**Planned Unit Development (PUD)—
Brixmor Property Group, LLC**

RECOMMENDATION REPORT

CASE NUMBER: PPUD-19-0002

RE: Planned Unit Development (PUD) Amendment
Initial Review
Brixmor North – Southport West

UTILITY PLAN
PUD PLANS
BRIXMOR NORTH
LOTS 2, 3, 19, 20

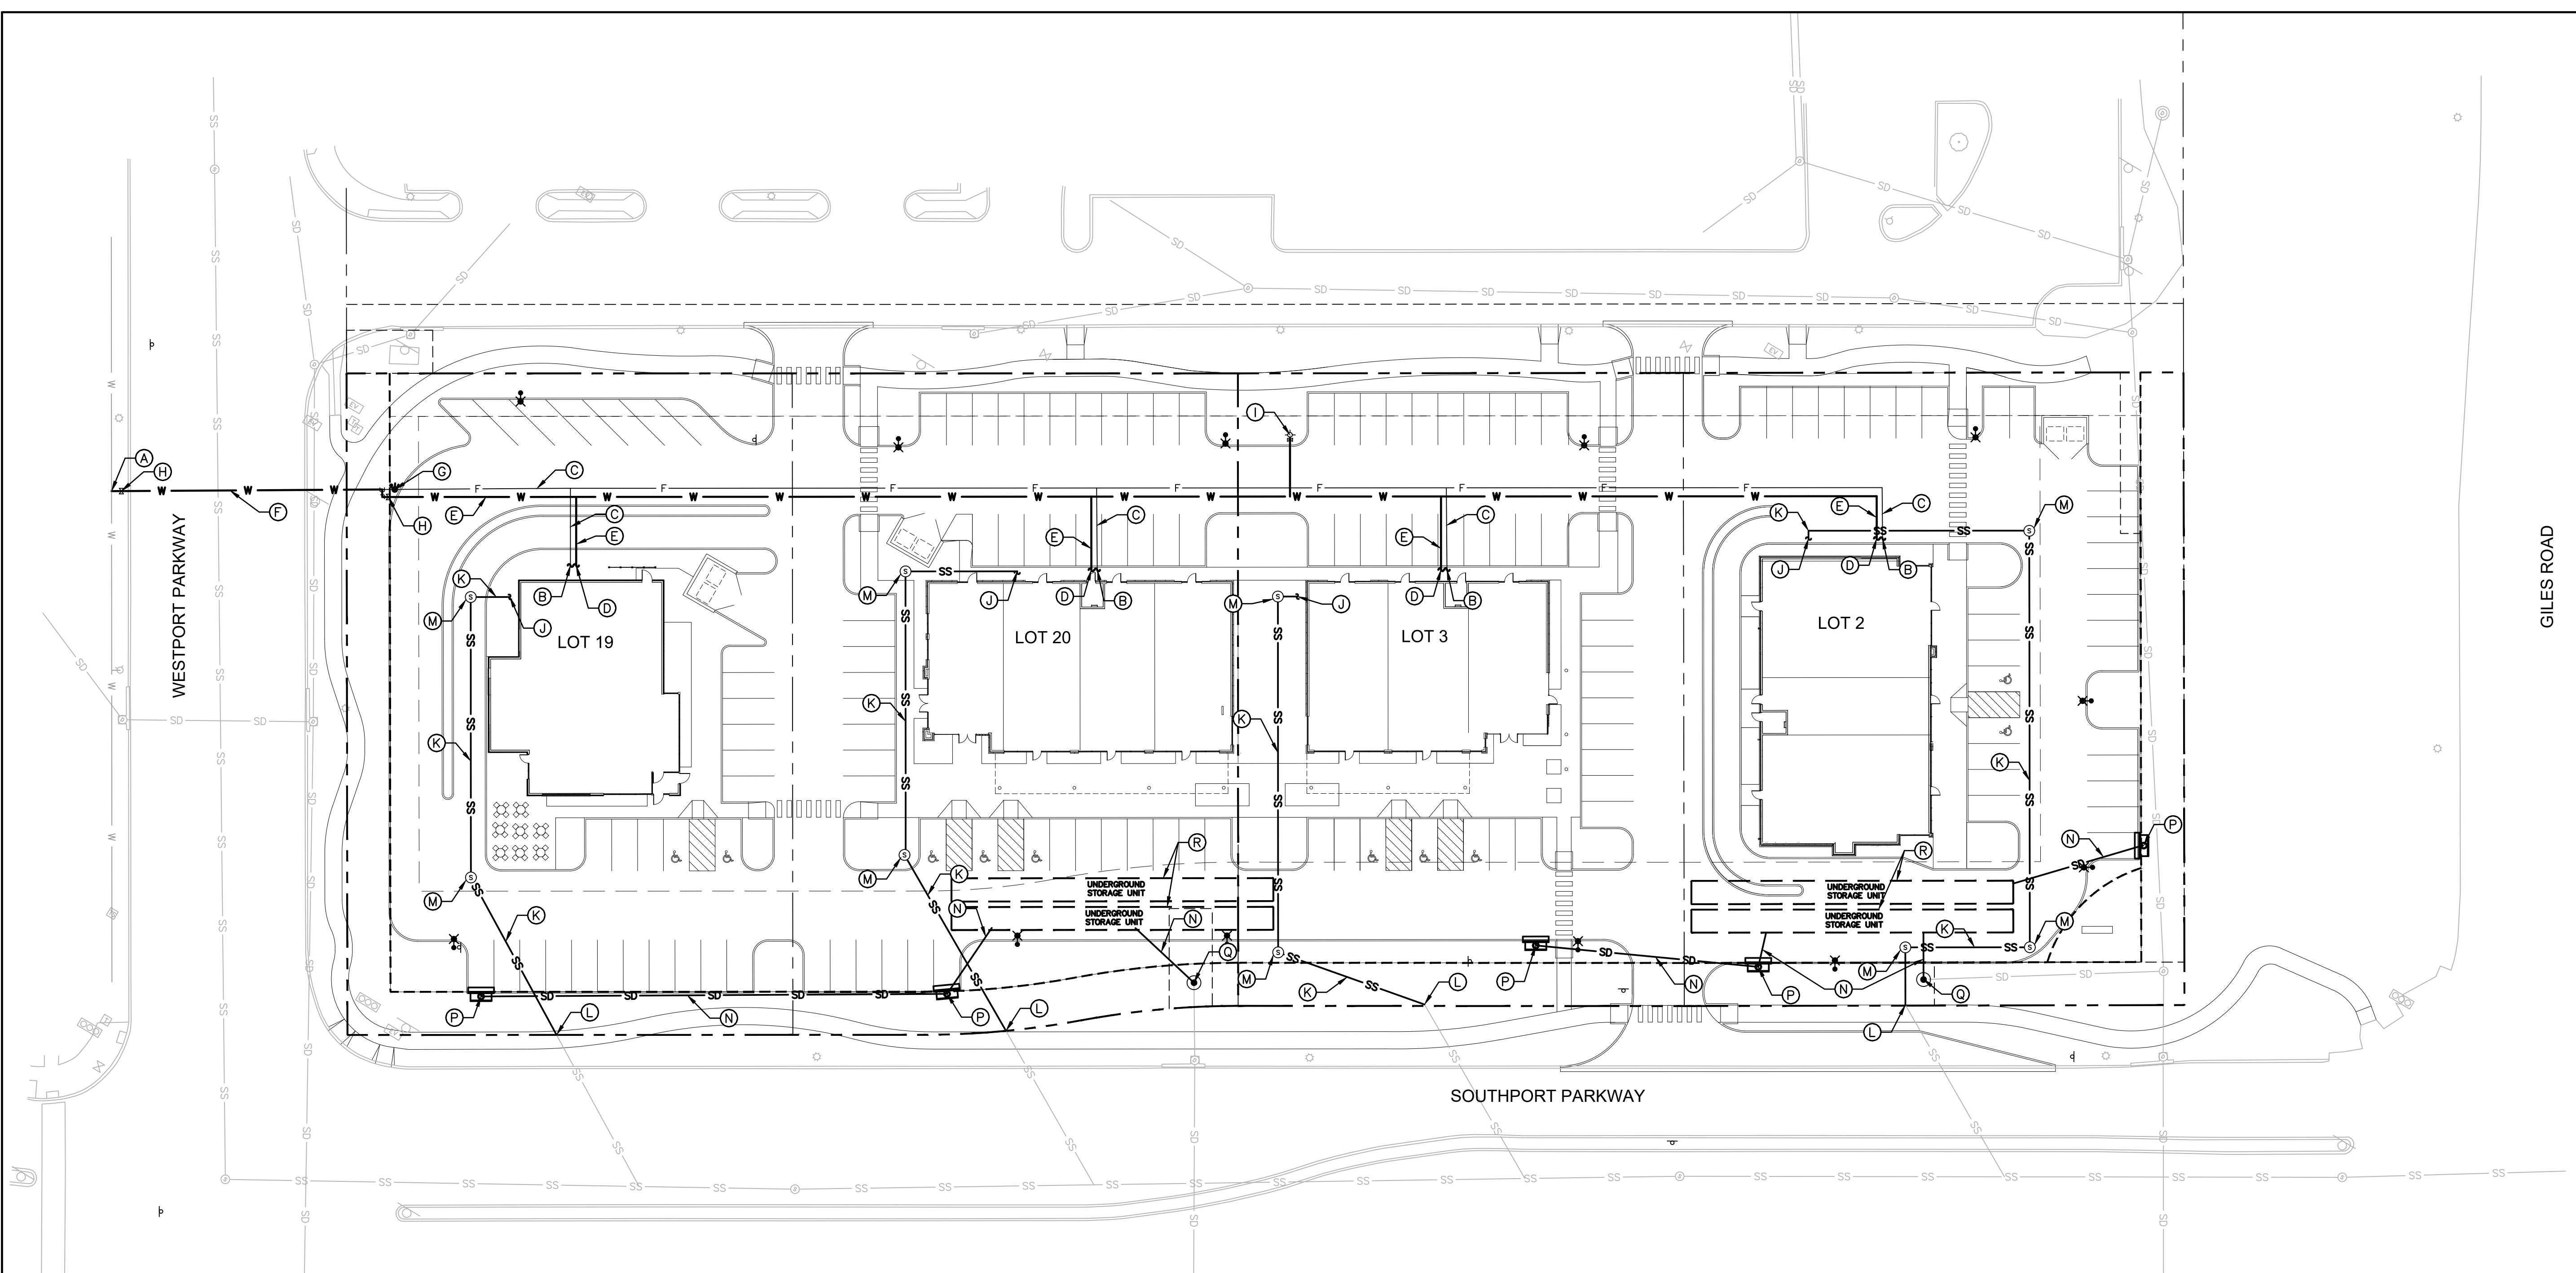
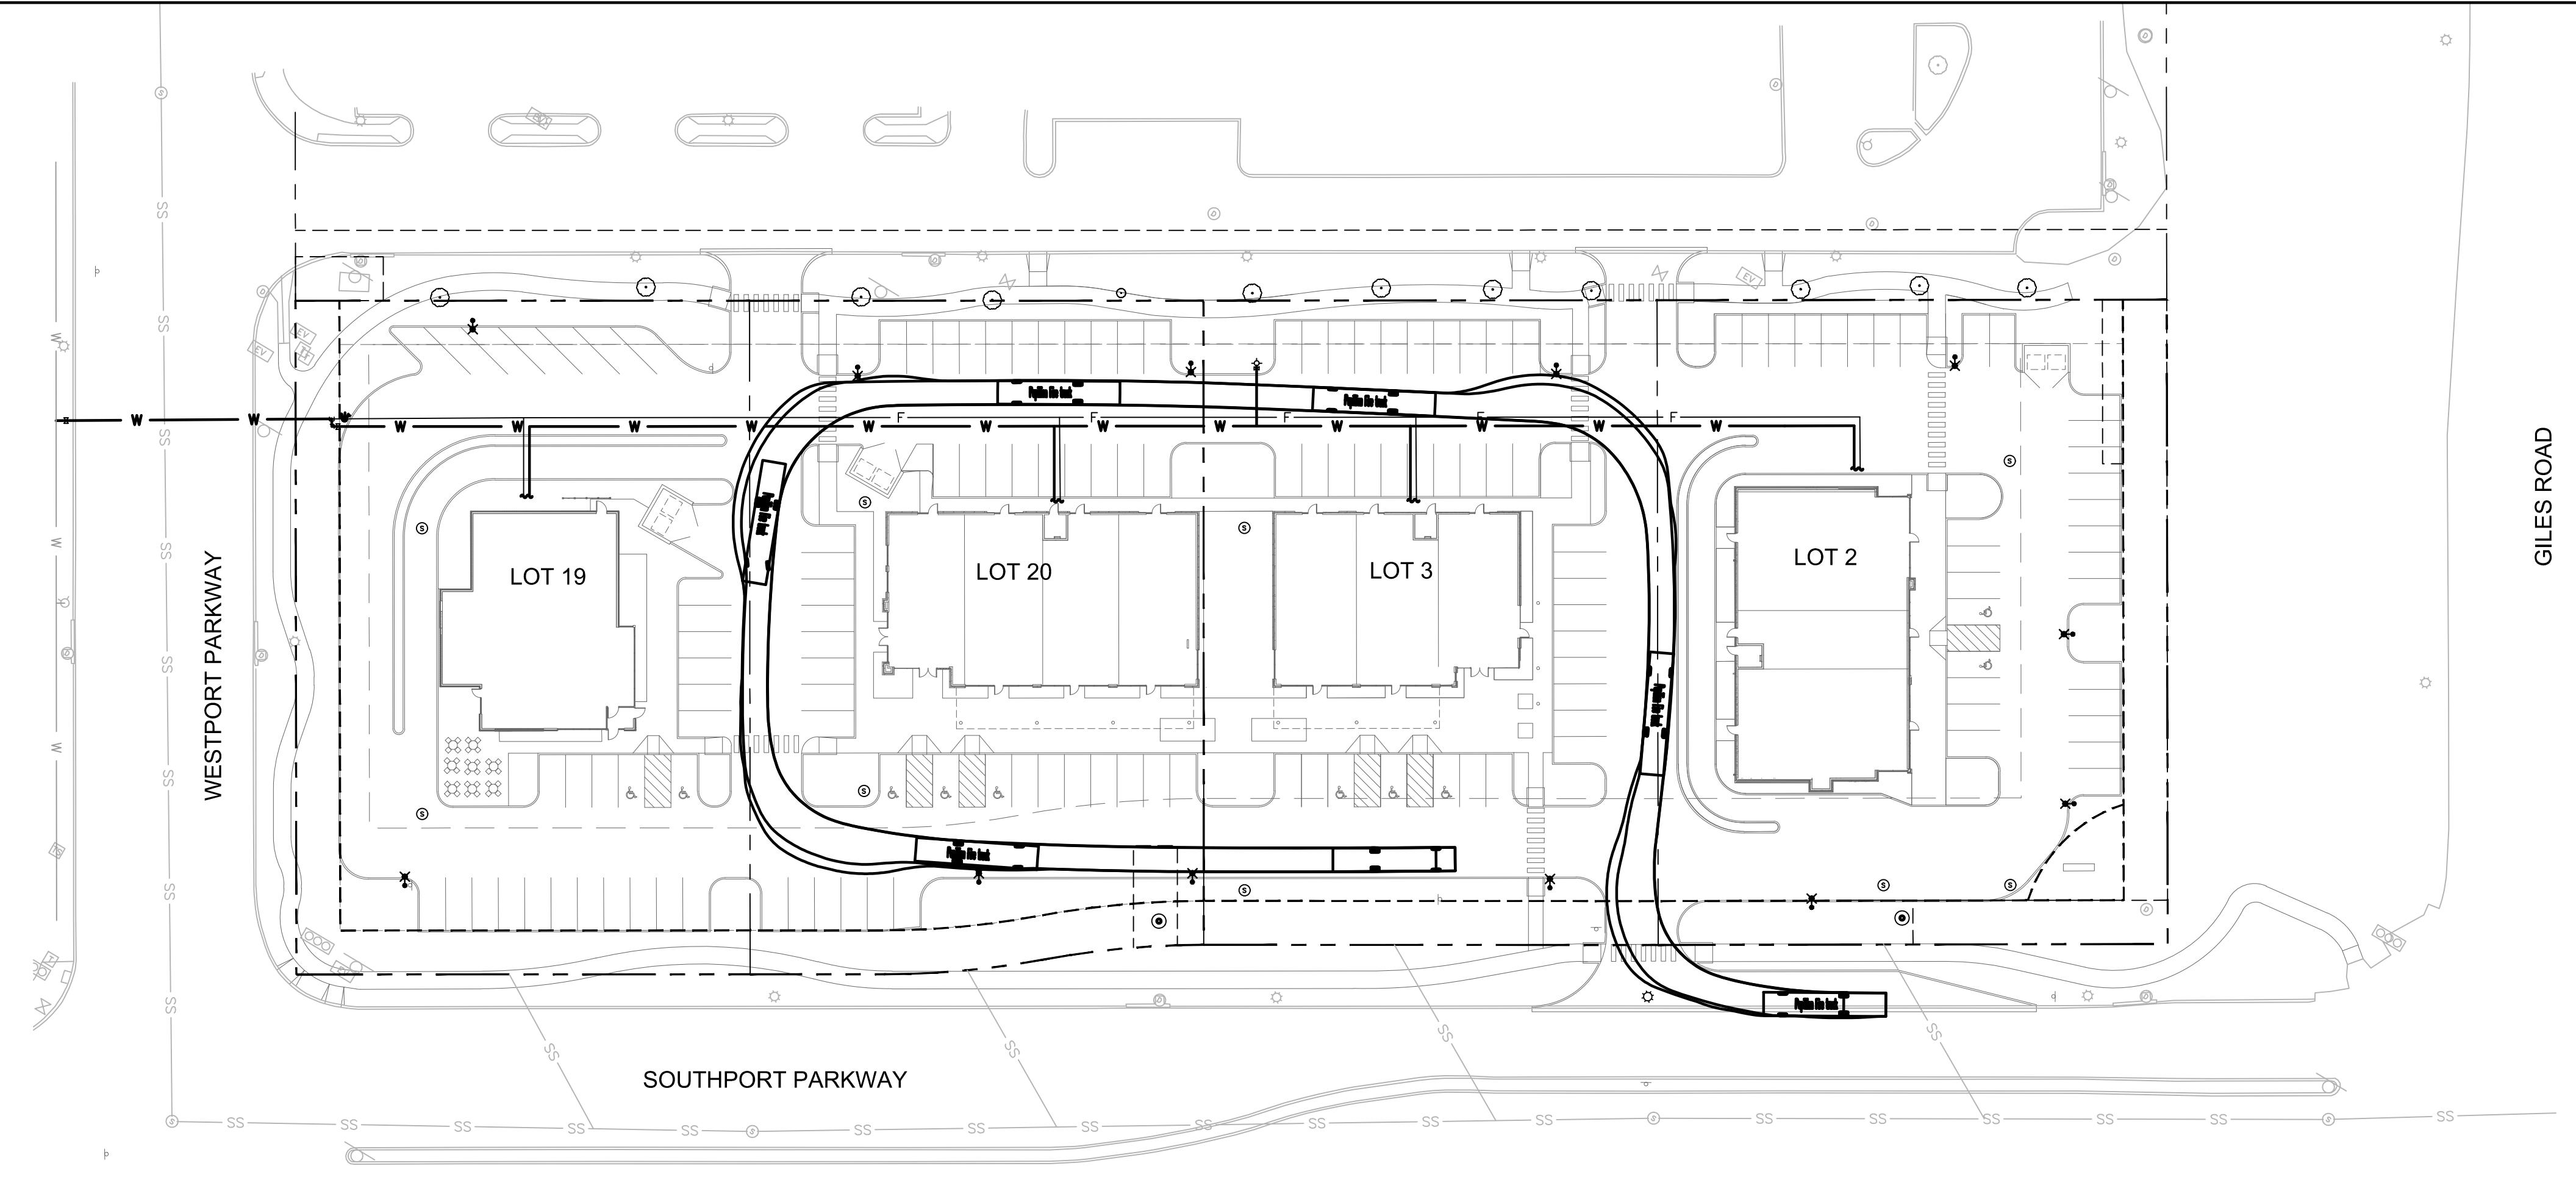
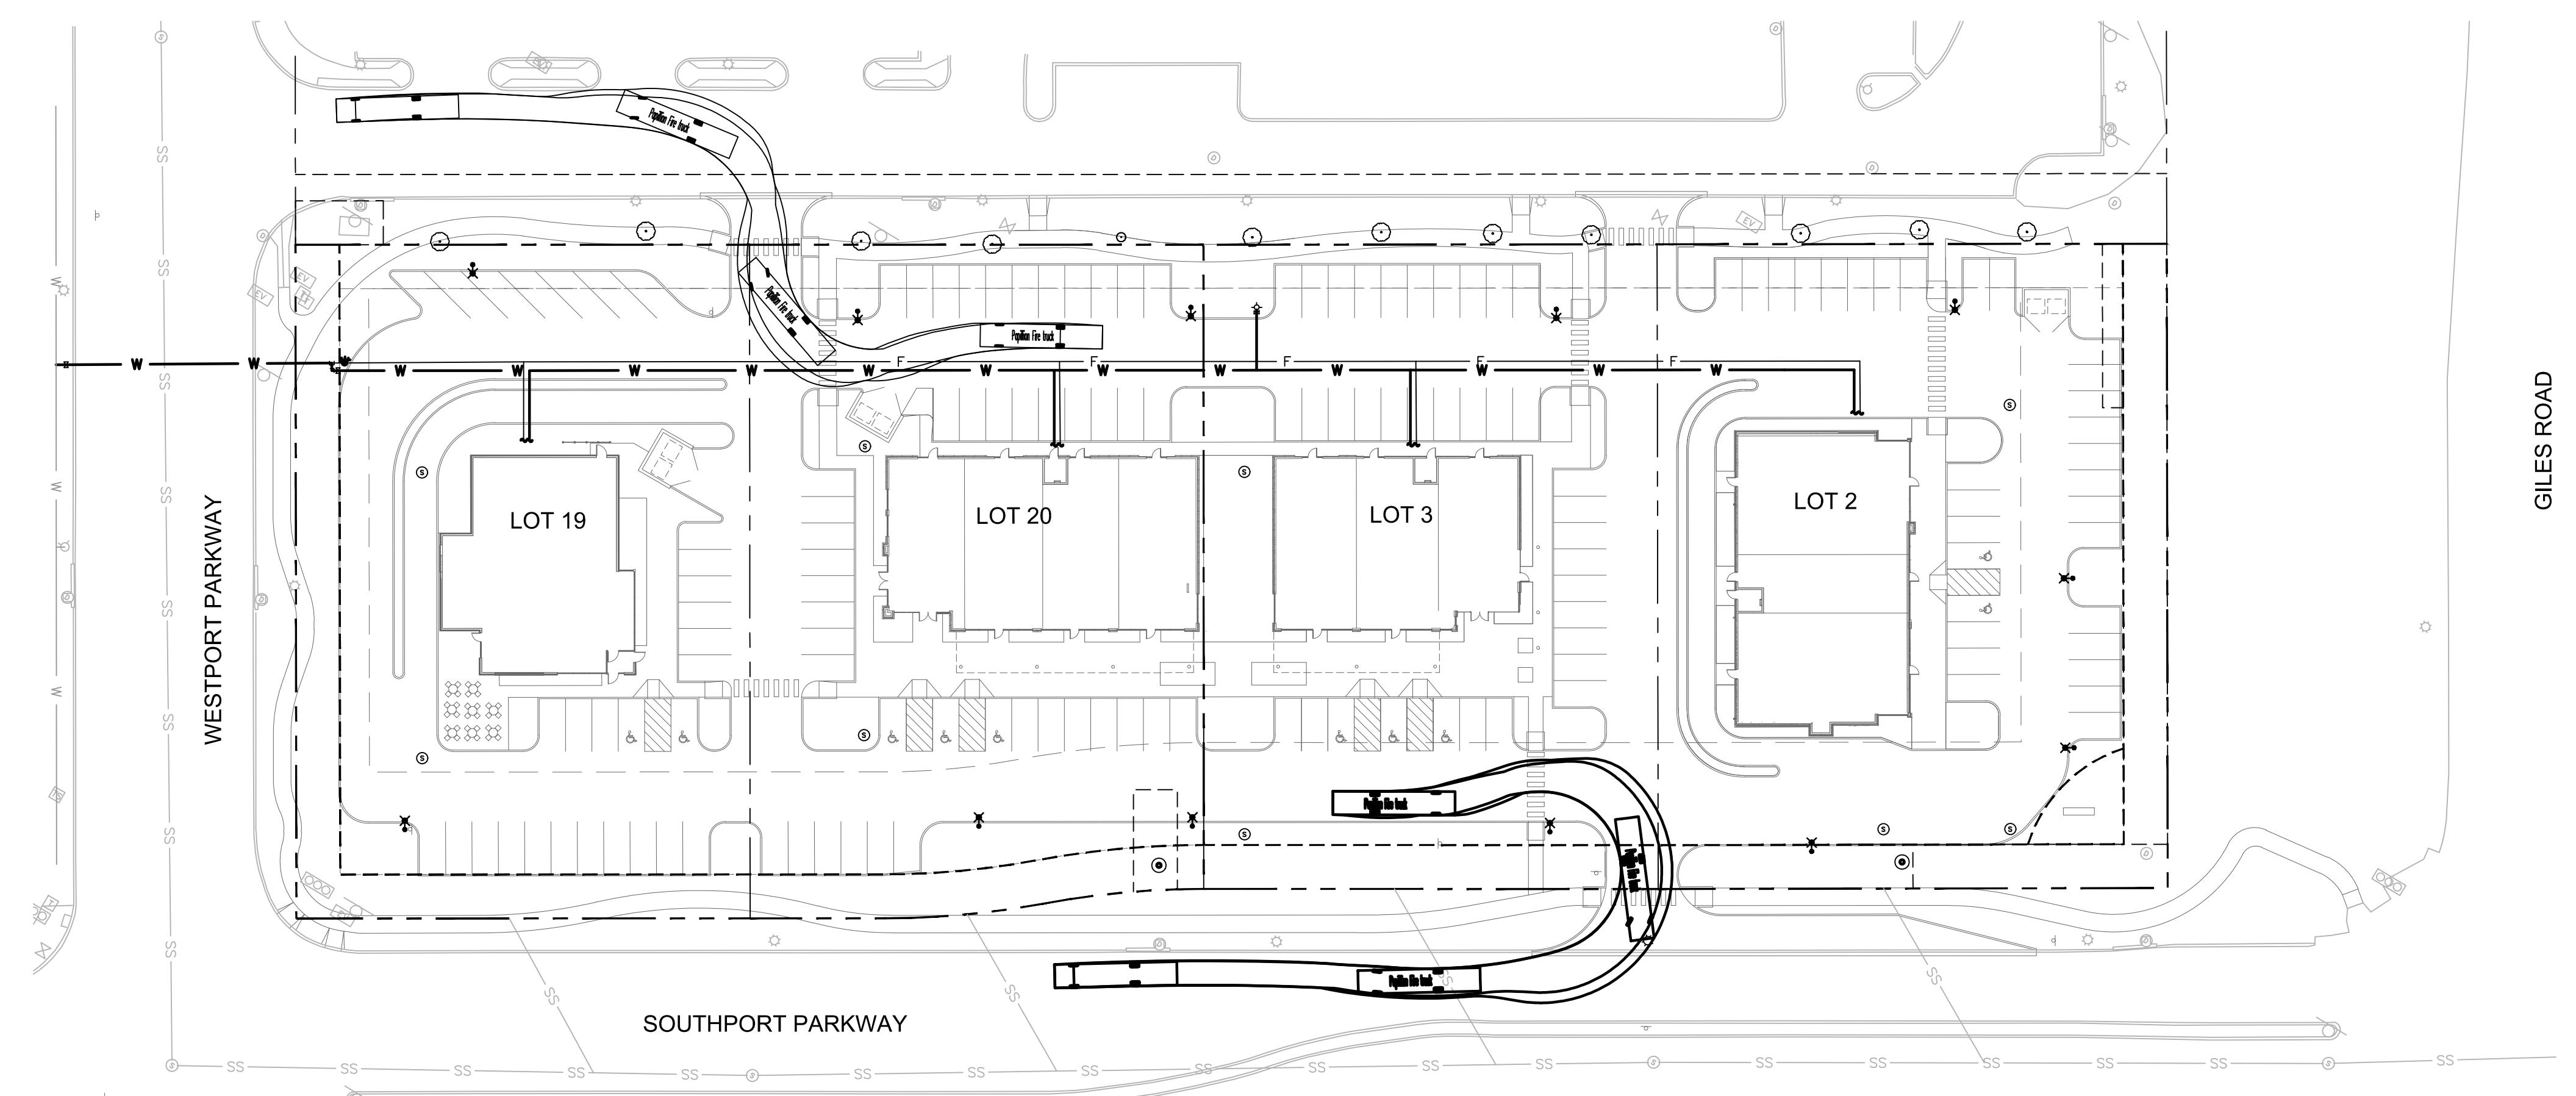
Sheet C4.1

- Please confirm that the water main on the hotel lot proposed for connection is a public water main.
- The proposed sanitary sewer is running against the topography to reach Westport Parkway. There may be stub outs in Southport Parkway that could be able to serve the lots.
- PCSMP Plan will need to be reference to this drawing as well.
- If the existing storm sewer at the northeasterly side of Lot 2 is outside of the 15 ft easement as it is shown, additional easement will be required.

Sheet C4.1

- Please confirm that the water main on the hotel lot proposed for connection is a public water main. **Response: We have coordinated with MUD for the main locations and revised the plan to connect to the main in Westpoint Parkway.**
- The proposed sanitary sewer is running against the topography to reach Westport Parkway. There may be stub outs in Southport Parkway that could be able to serve the lots. **Response: Based on GIS, there are no stubs in Southport Parkway to serve the lots.**
- PCSMP Plan will need to be reference to this drawing as well. **Response: PCSMP note has been referenced.**
- If the existing storm sewer at the northeasterly side of Lot 2 is outside of the 15 ft easement as it is shown, additional easement will be required. **Response: Based on survey, this line appears to be just inside of the easement line and has been modified accordingly.**

Sheet C4.1

- City provided to the Applicant's engineering consultant a scan of what is believed to be the as-built locations of the sanitary sewer stubs in Southport Parkway, to which each lot should have a stub out to Southport Parkway.
- Per the engineering consultant's response letter, the storm sewer on the northeasterly side of Lot 2 is stated to be within an existing easement. However, it does not appear so in the revised plans. The easement would appear to need to be modified.

SHEET
 C5.1

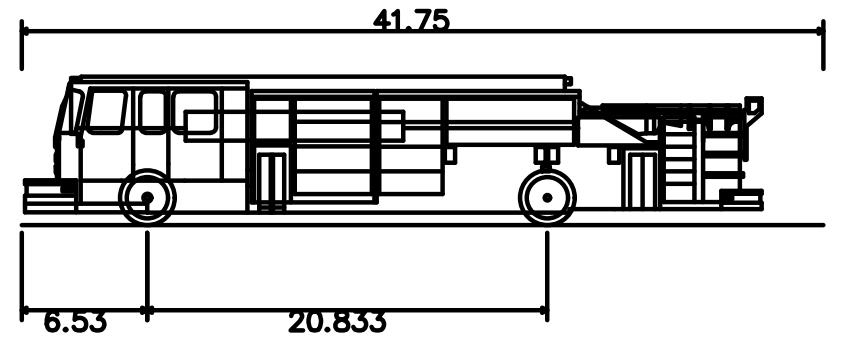
A separate Emergency Vehicle Access Plan which includes Site Plan, Fire Lane, Fire Hydrants, PIV, and FDC - Use Auto-Turn Professional, or similar program, using specifications provided by Fire Marshal.

A separate Emergency Vehicle Access Plan which includes Site Plan, Fire Lane, Fire Hydrants, PIV, and FDC - Use Auto-Turn Professional, or similar program, using specifications provided by Fire Marshal. **Response: A fire access plan has been provided with the submittal.**

Sheet C5.1

- In the Emergency Vehicle Access Plan, the proper apparatus turning radii and proper vehicle size were not used. The proper apparatus, provided by the Fire Marshall, is attached. Please adjust the turns and display the proper basis/legend in the top-right corner.
